To: Daniel Suarez, Kimley-Horn
From: Pat O’Mahony, Associate Planner; 910-341-0189
CC: Jeff Allen, CBL Properties
Date: 7/25/2019
Re: Mayfaire Self Development Planning Staff Review ver. 1

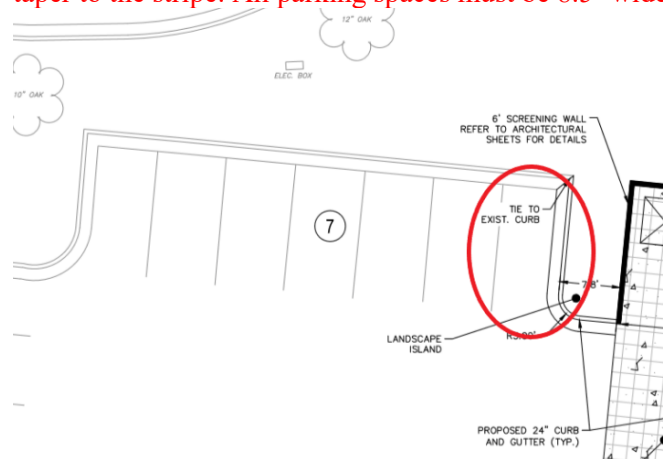
- Sec. 18-60 (c) (5): Additional information is the site data table as follows:
 - Off street parking calculations, including required amount of parking and proposed amount of parking and the basis for determination
 - **Comment: Based on the MX district, there are no parking minimums. Please update site data table to reflect the lack of a parking minimum.**
- Sec. 18-60 (c) (10): Show Location and dimension of on-site pedestrian and vehicular access ways, **parking areas, loading and unloading facilities**, designs of ingress and egress of vehicles to and from the site onto public streets and curb and sidewalk lines.
 - **Comment: The parking space shown below measures 7’ wide from the taper to the stripe. All parking spaces must be 8.5’ wide.**
